Access Compliance Report

Public Rights-of-Way

(Curb Ramps)

Intersection ID: 10040204	Main Street: TYVOLA_RD	Cross Street: N/A	Location: SW
ADA ID: C9563FB4D08F	Ramp Type: ParaDiag	Initial Pass/Fail: Fail	Overall Compliance: No
		Severity Score: 25

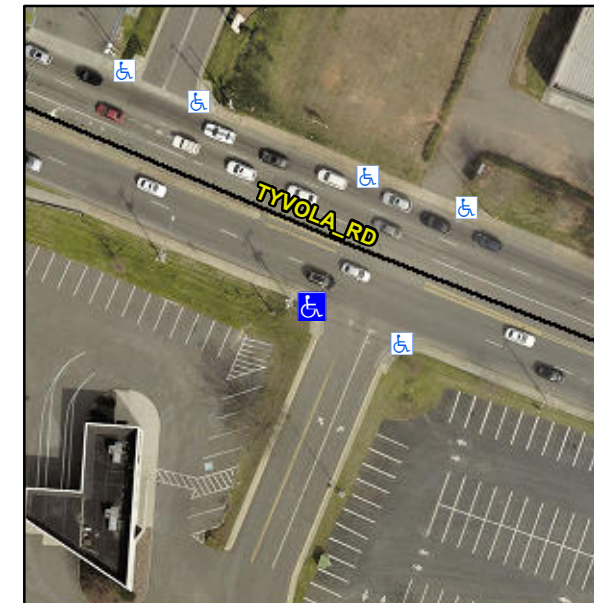
R304.3.2

Compliance	Description	Data	Compliance	Description	Data
N/A	Ramp Length LT (in)	25.0	N/A	Ramp Length RT (in)	57.0
Yes	Ramp Width LT (in)	58.0	Yes	Ramp Width RT (in)	58.0
Yes	Ramp Slope LT (%)	5.9	No	Ramp Slope RT (%)	15.0
Yes	Ramp XSlope LT (%)	0.7	Yes	Ramp XSlope RT (%)	0.7
N/A	Landing Length (in)	N/A	N/A	DWS Provided?	N/A
N/A	Landing Width (in)	N/A	N/A	DWS Contrast?	N/A
N/A	Landing Slope (%)	N/A	N/A	DWS Length (in)	N/A
N/A	Landing X Slope (%)	N/A	N/A	DWS Full Width?	N/A
N/A	Landing Curb? (Y/N)	N/A	N/A	DWS Offset (in)	N/A
N/A	Shared Landing?	N/A			
N/A	Gutter Ponding?	N/A	N/A	Gutter Slope (%)	N/A
N/A	Gutter Lip Ht (in)	N/A	N/A	Gutter X Slope (%)	N/A
N/A	Painted X Walk1?	No	N/A	Painted X Walk2?	No
	X Walk 1 Direction	To SE		X Walk 2 Direction	To NE
N/A	X Walk 1 Width (in)	N/A	N/A	X Walk 2 Width (in)	N/A
	X Walk 1 Slope (%)	4.1		X Walk 2 Slope (%)	0.0
	X Walk 1 X Slope (%)	1.8		X Walk 2 X Slope (%)	3.0
N/A	Ramp inside XWalk1?	N/A	N/A	Ramp inside XWalk2?	N/A

Remove & Replace Curb Ramp With Two New Directional Ramps or Equivalent.
